Service Update

A202299960 Shift Lever Cable Bolt Not Fully Fastened

Release Date: June 2020

Revision: 01

5569860

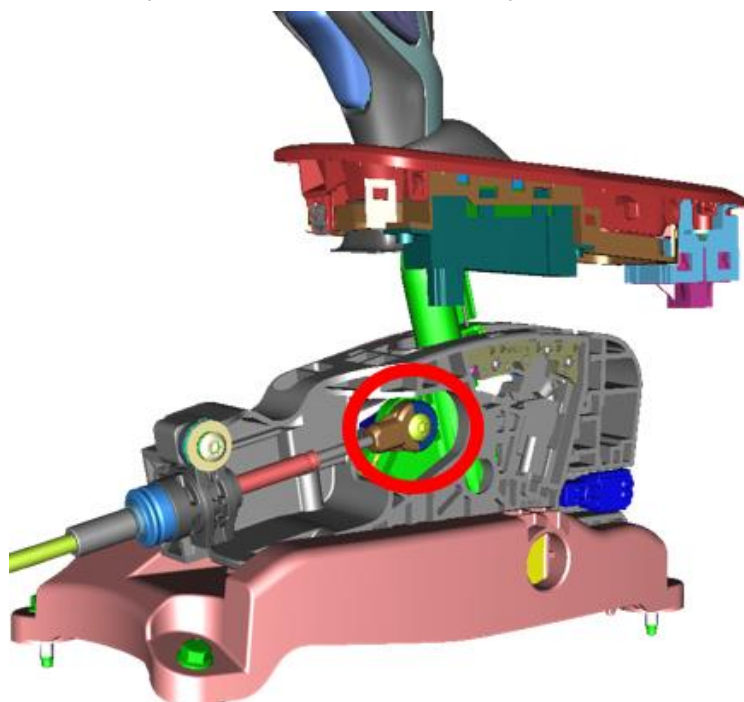
Caution: During part replacement, check to ensure the circled fastener is fully seated.

4. Replace the Transmission Range Selector Lever Cable. Refer to *Automatic Transmission Range Selector Lever Cable Replacement* in SI.
